**TOWN OF BAY HARBOR ISLANDS
MORRIS N. BROAD COMMUNITY CENTER
1175 95TH STREET
BAY HARBOR ISLANDS, FL 33154**

DEVELOPMENT & REVIEW COMMITTEE MEETING

RESPONSE LETTER TO COMMENTS ROUND #1

PROJECT: BAY HARBOR LUXURY TOWNHOMES

EAST &
NORTH
ELEVATIONS

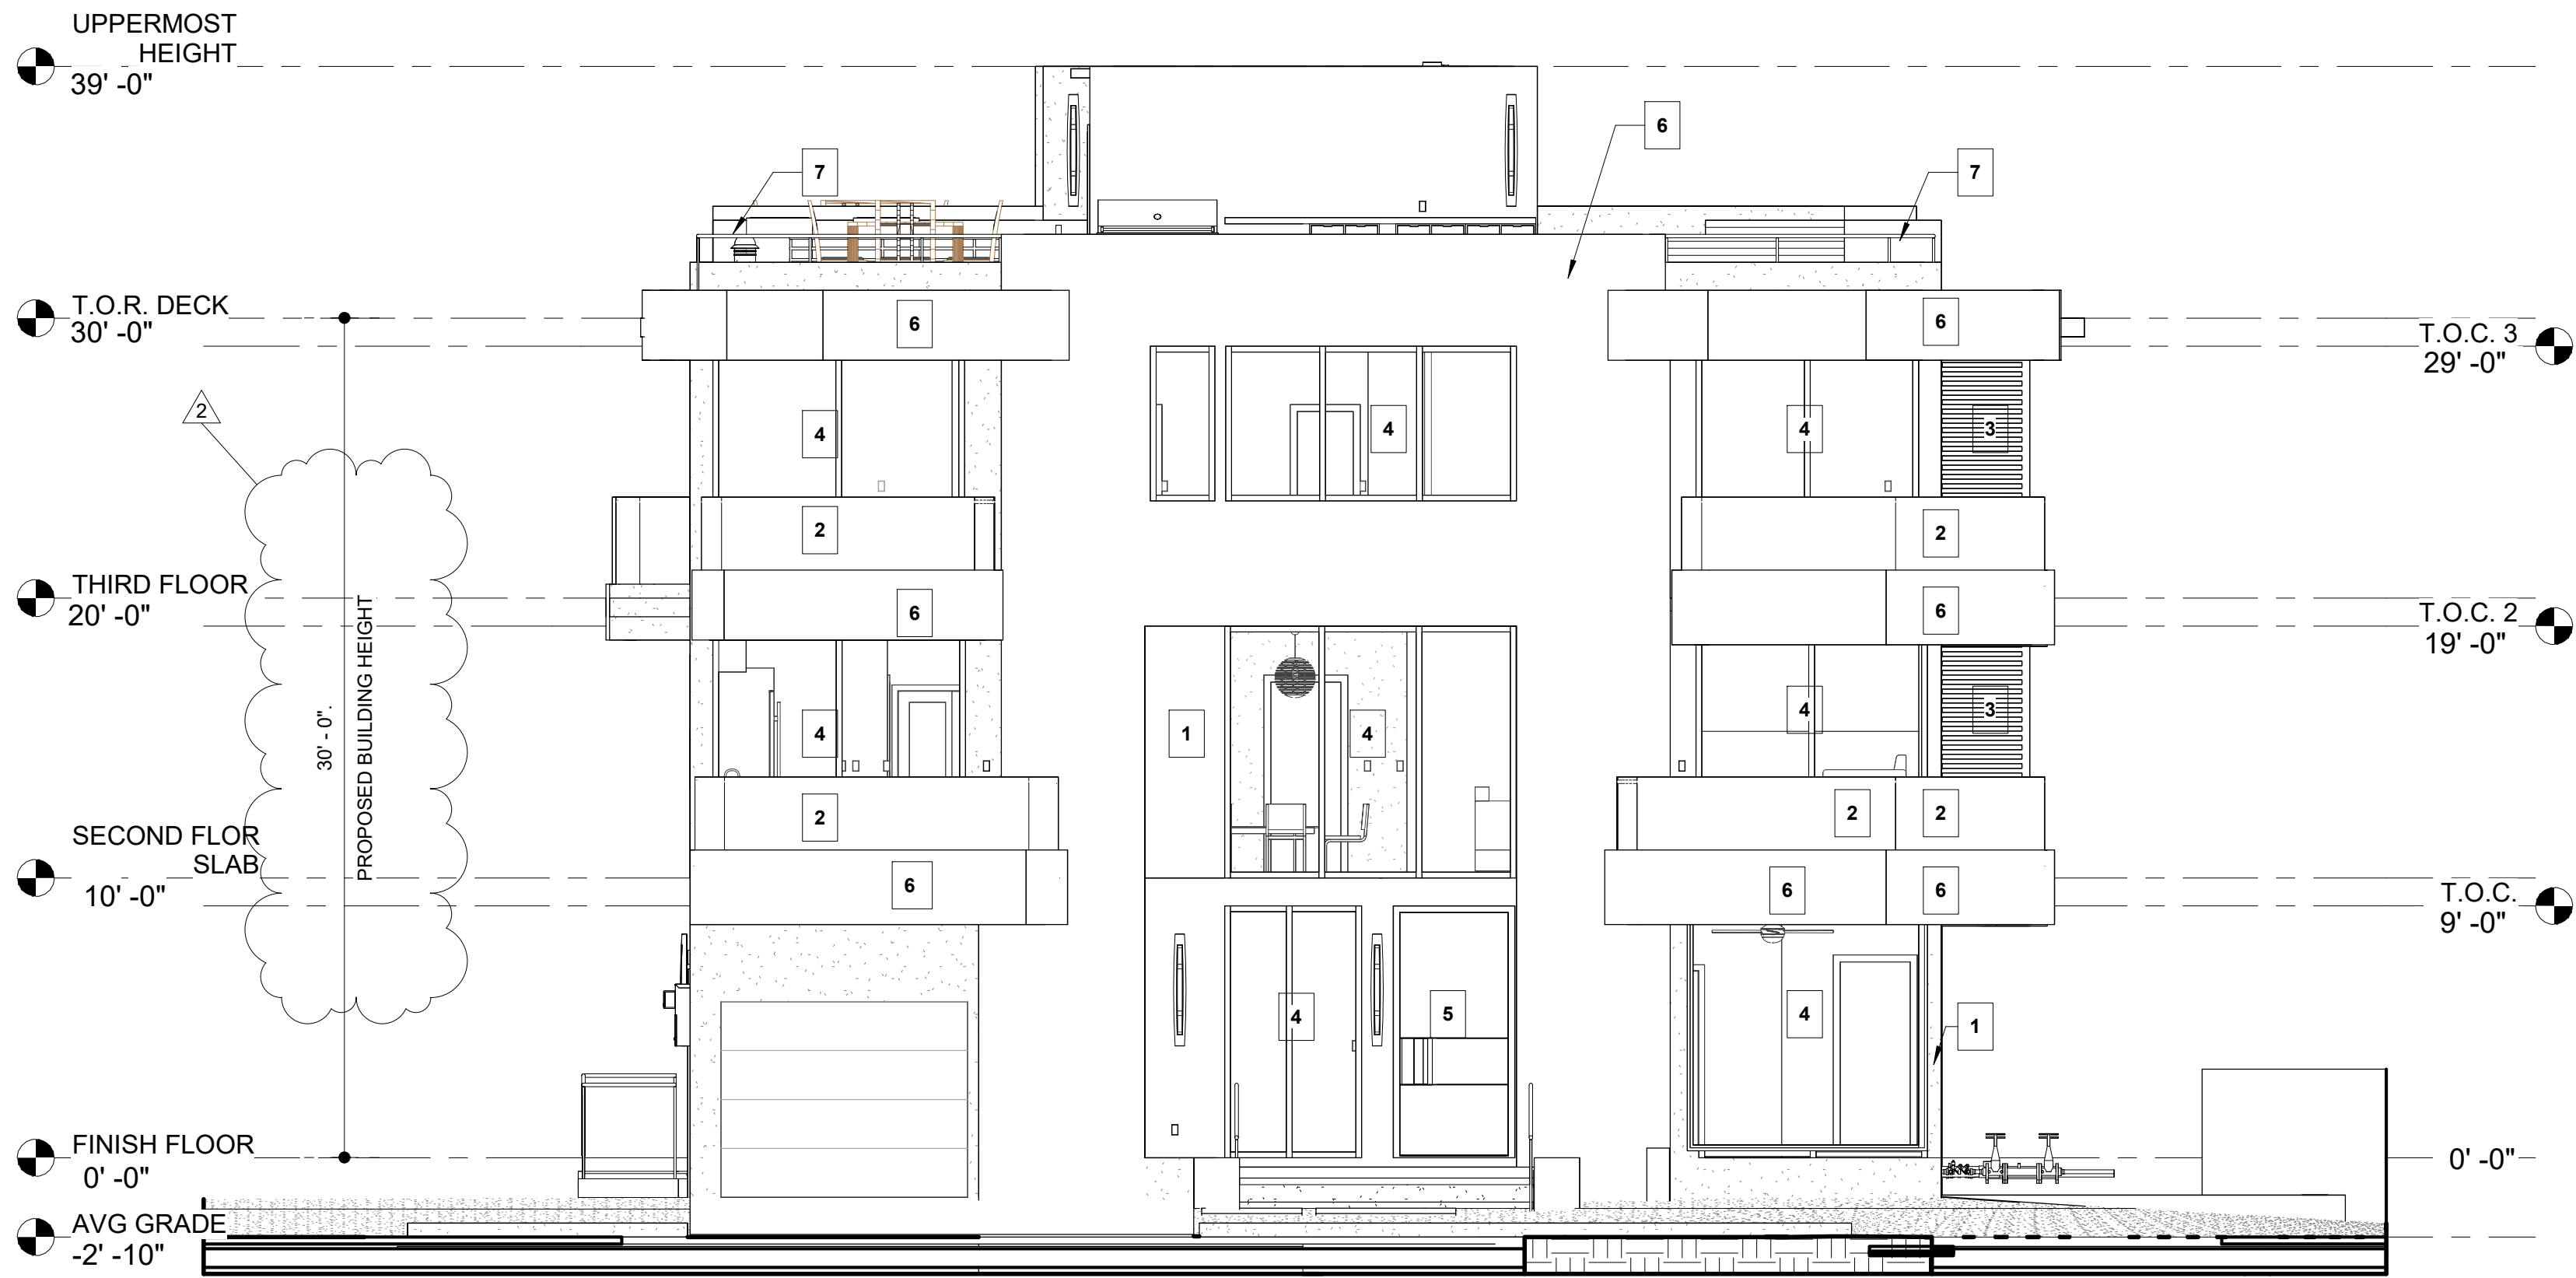
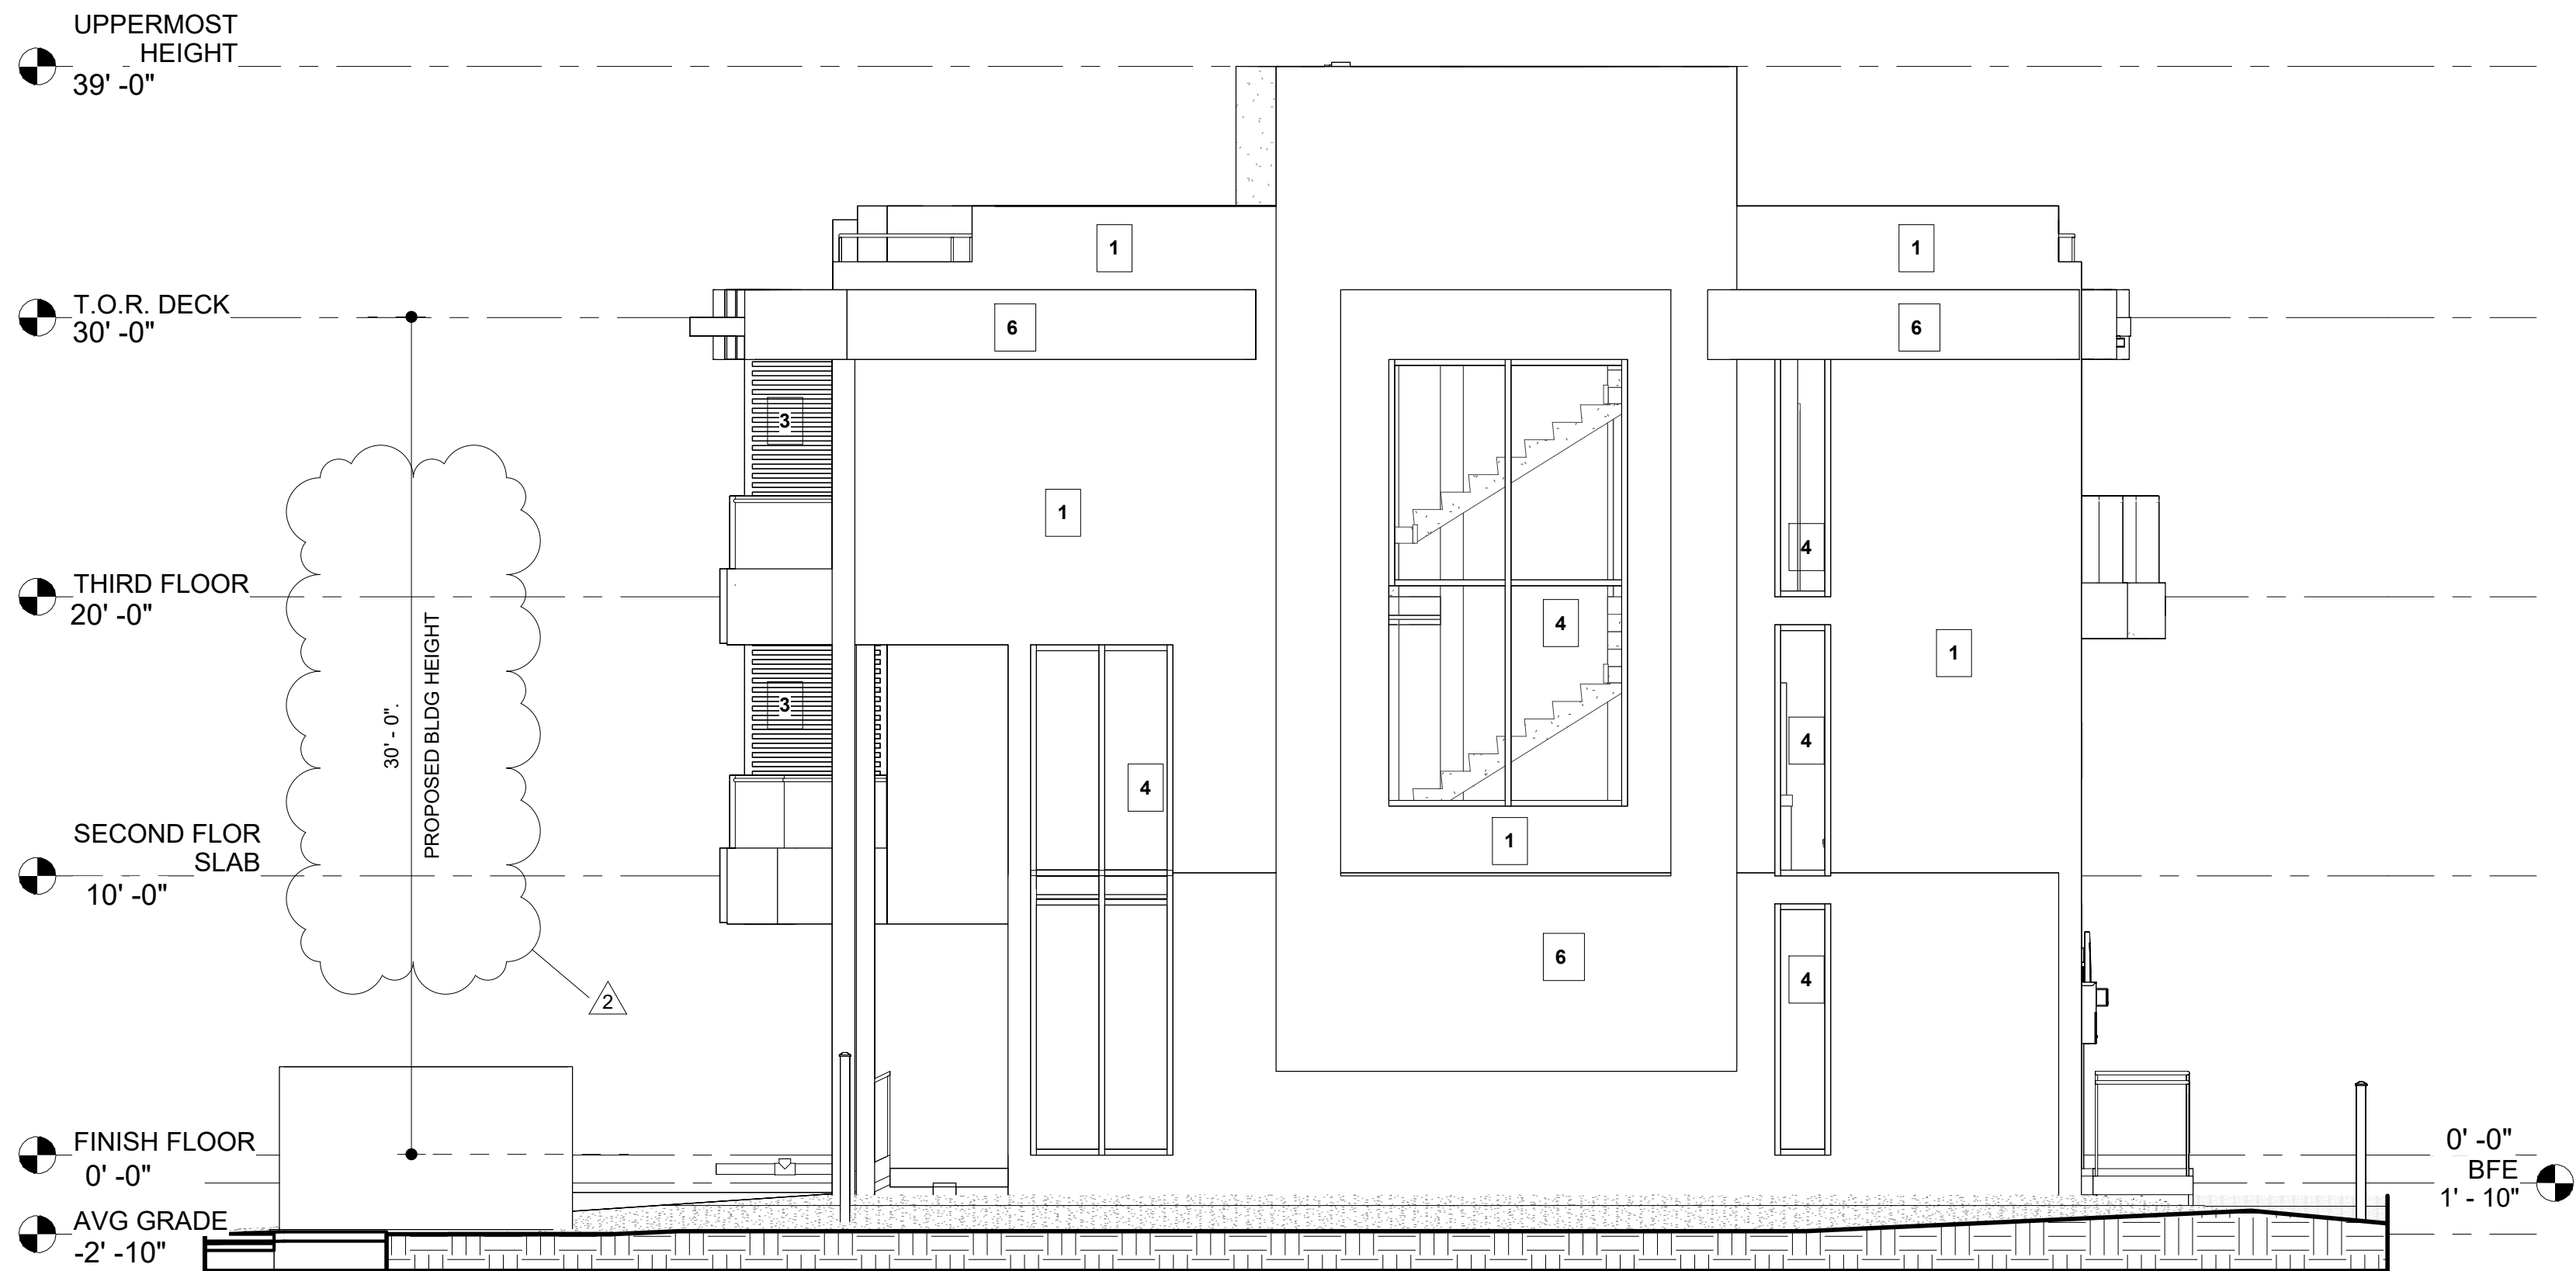
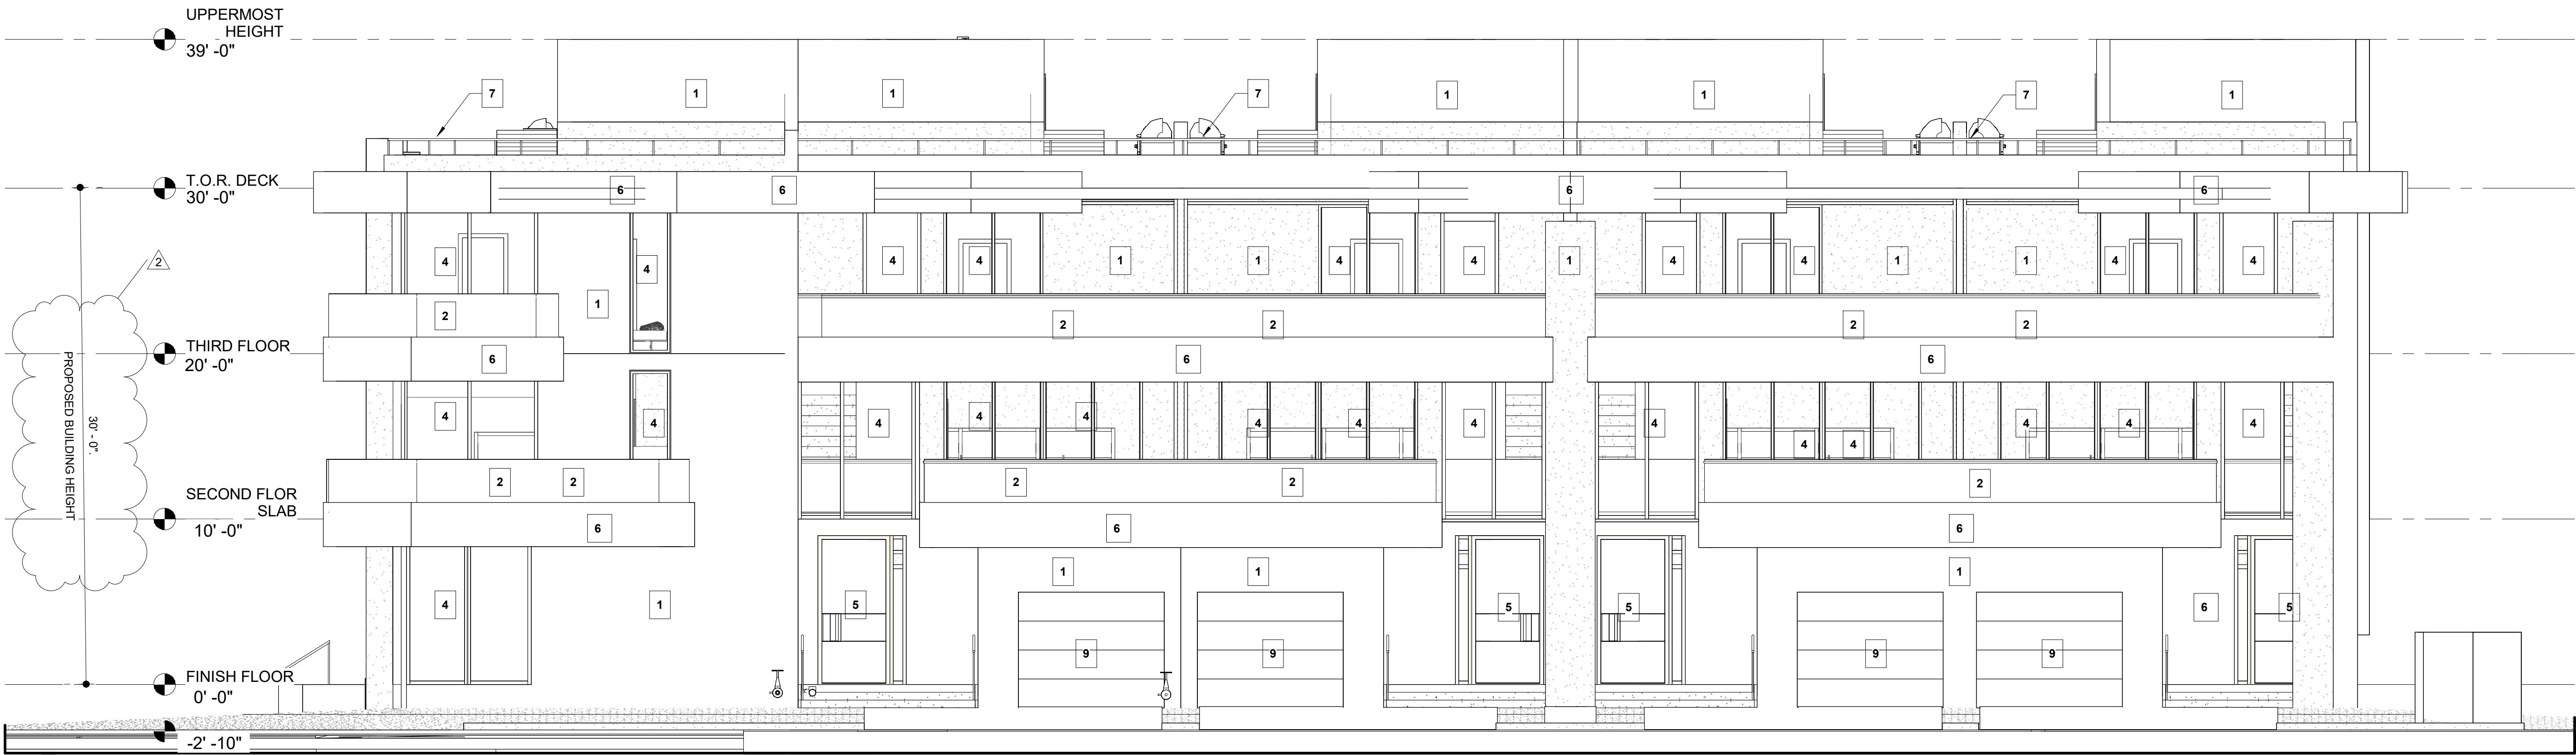
- a) the maximum height allowed should state 65'-0" above BFE +1. FBC FREEBOARD.
R/ SEE SHEET A-01 ZONING CODE APPLICATION TABLE
 - b) THE HIGHT PROVIDED IS 37' – 10" ABOVE BFE. T THE MAIN ROOF DECK, ALTHOUGH THERE ARE PORTIONS OF THE BUILDING THAT EXCEED THAT (ACCESS ELLEVATOR / STAIRS) (47' – 10")
R/ BUILDING ADJUSTED TO MEET HEIGHT ALLOWED, TO 30'-0" FROM FFE (DFE) SEE ELEVATIONS AND SECTIOSN SHEETS A-103, A-104, A-105

R/ BUILDING ADJUSTED IN HEIGHT TO MEET THE REQ'D 30' HEIGHT, THEREFORE ADDITIONAL SETBACK IS NO LONGER NEEDED. SEE ELEVATIONS SHEET A-103, A-104
